# **Trumbull High School Baseball Field**

**Trumbull, Connecticut**

## **Environmental Review Team Report**

**August 2000**

## Project Layout

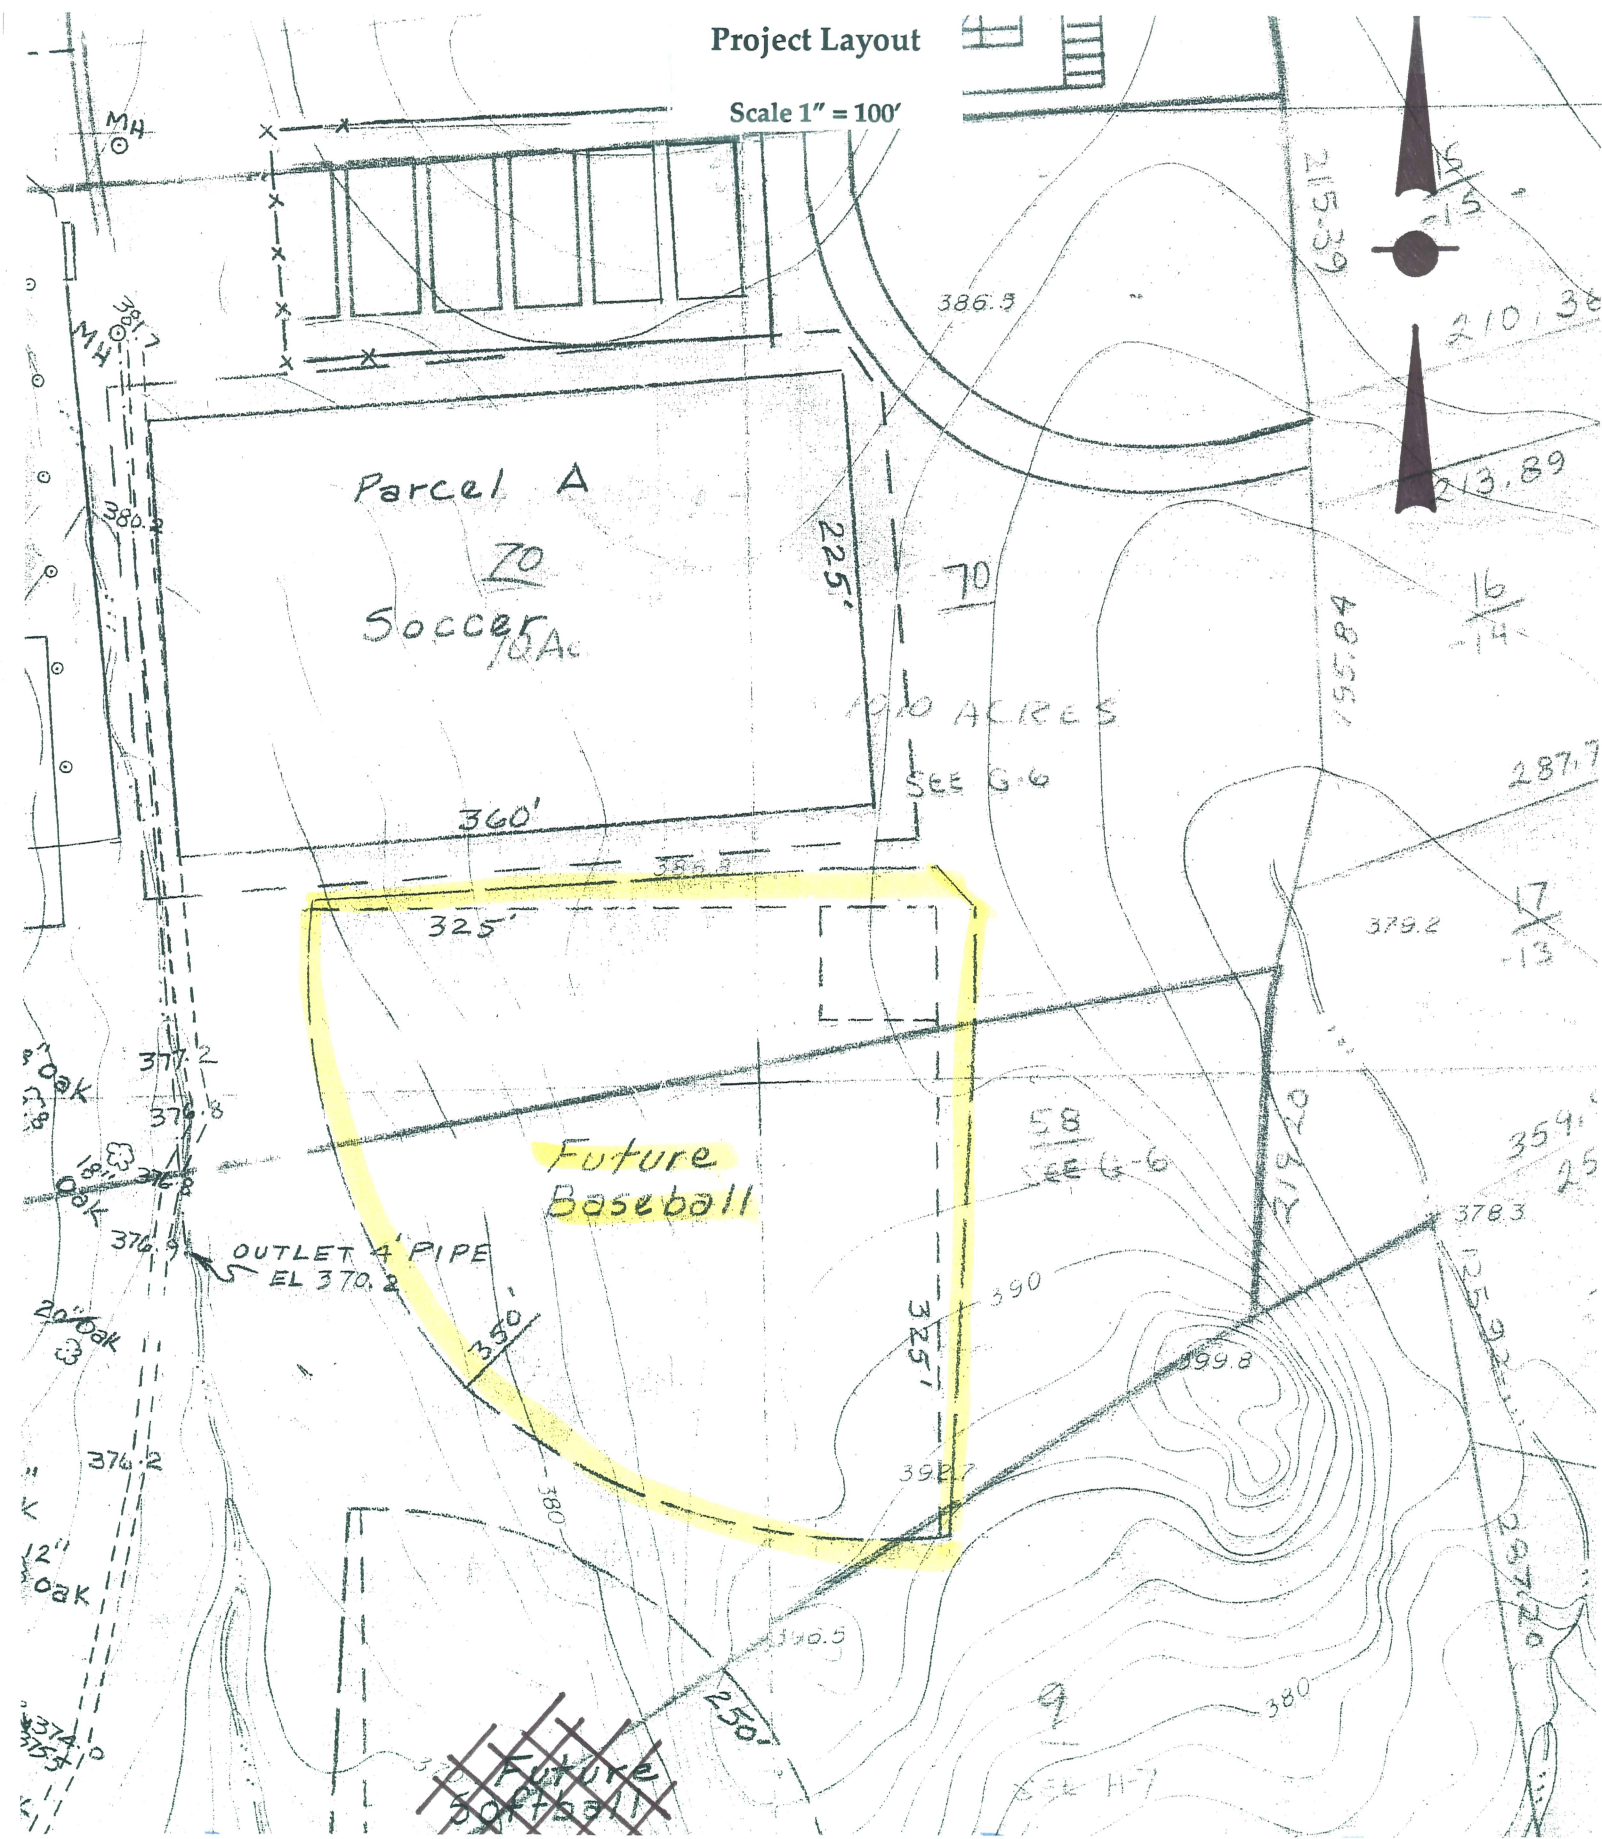
Although the soil resources don't inhibit the feasibility of placing the proposed baseball field in the area of the existing outdoor classroom and portion of the cross-country trail, it seems unnecessary. Placing the baseball field in the proposed area will cause the deforestation of an area that now serves the school in two ways, and will replace it with a field that will serve only one purpose, this does not seem to be a good trade off. The re-orientation of the existing fields seems to be a more practical approach to the athletic and educational needs of the school. A more environmentally sensitive and cost effective manner of utilizing land that is already cleared for construction reduces costs and allows resources to be applied to "parcel B." "Parcel B" if planted Fall 2000 could be used as a playing field sooner than was indicated during the field walk on June 28, 2000. The Conservation District has offered one possibility that can be seen (Figures 5 and 6).

- 1) Cut back into slope of existing softball field, top of existing slope to be out of bounds line for new field.
- 2) Use noted dimensions for "future field", 350' to center field fence, 325' to side line boundary.
- 3) Field F to be moved to unused area, "parcel B."
- 4) Field H to be shifted beyond fence for new field.

Figure 7.  
Wetland Review Map

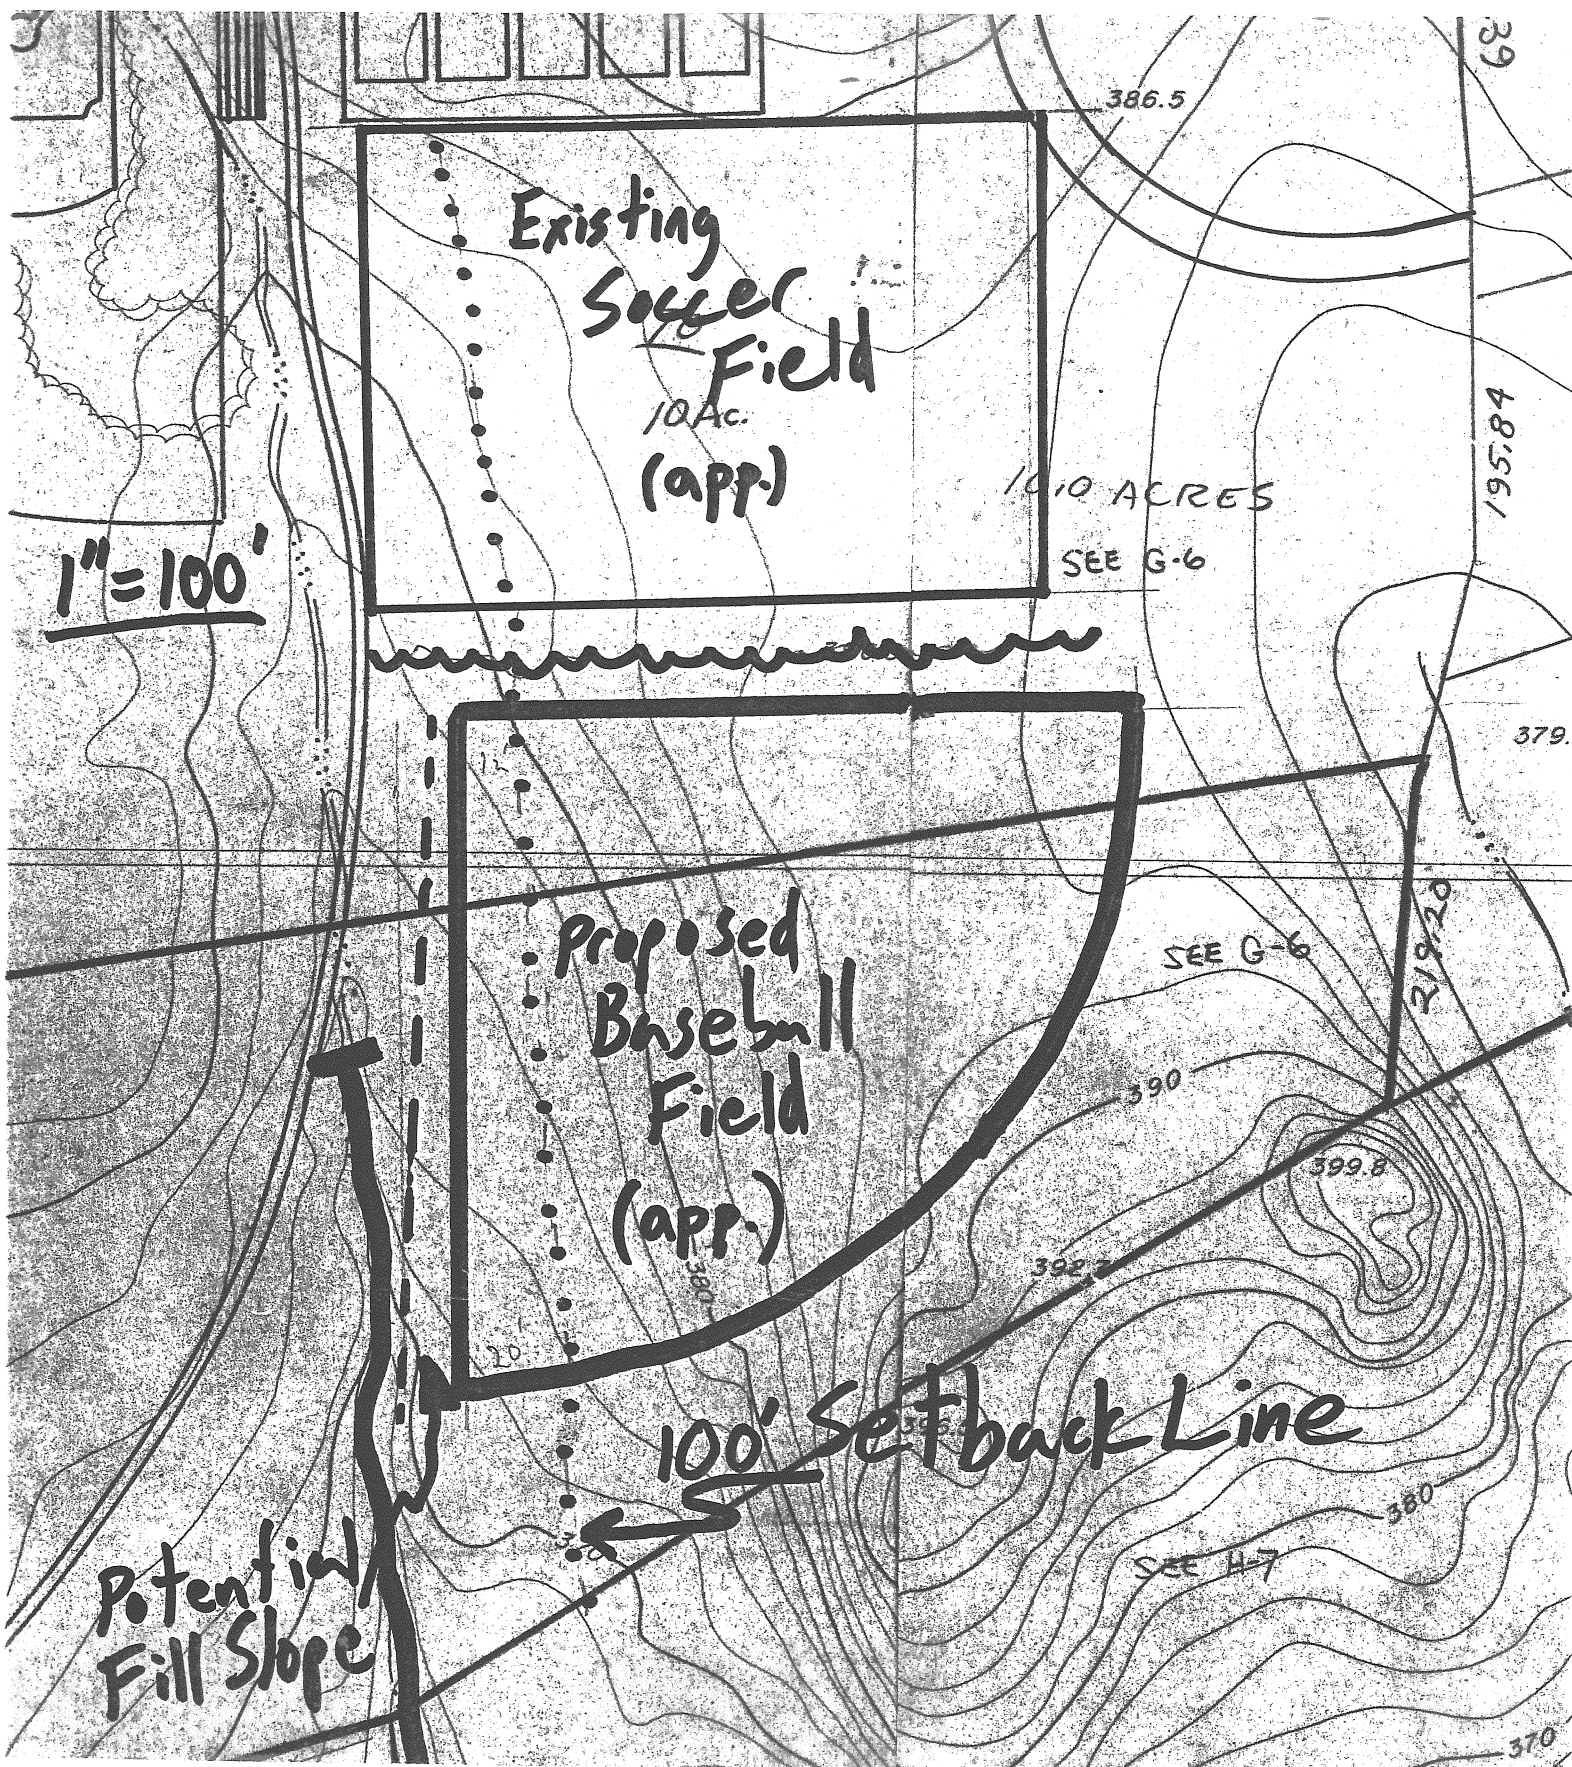
Assuming that the baseball field has similar dimensions as the nearby baseball field, an approximate representation of the proposed activities was sketched onto town planimetric mapping (see Figure 7).

Given the topography, there will most likely need to be some grading of the site to create a level playing field. Possible shallow depth-to-bedrock in the southeastern portion of the proposed playing area may dictate that there be more addition of earth material than removal of earth material to achieve the desired elevations, unless blasting of bedrock is performed if encountered.

At any rate, some amount of filling will most likely be needed in close proximity to the watercourse. Therefore an area of graded slope should be incorporated into the plan. With estimated fill of between 10 and 20 feet, this could mean an additional 20 to 40 feet of graded fill slope added on to the playing surface. This means that, according to Figure 7, disturbance may come as close as 10 feet from the watercourse and never more than 30 feet away.

As previously mentioned, the amount of undisturbed riparian buffer left once the proposed ball field is in place will be minimal and most likely ineffective. In fact, many times in situations like this, the narrow band of natural vegetation that remains is eventually removed through periodic mowing.

It is suggested that the Town of Trumbull seriously consider alternatives to this proposed activity in order to reduce the potential for impacts as cited above. If possible, shifting the field as far to the east as possible, away from the watercourse should be investigated. However, the further to the east or south it is shifted, the higher the chance of encountering bedrock. Reducing the size of the field may be problematic if the goal of the proposal is to build an adult-sized baseball field as has been stated. There does not seem to be any reasonable realignment of the field that would reduce impacts without considerable expenditures for earth

removal and/or bedrock blasting. Options for utilizing currently open, yet unformalized sporting areas at this facility should be a primary consideration.
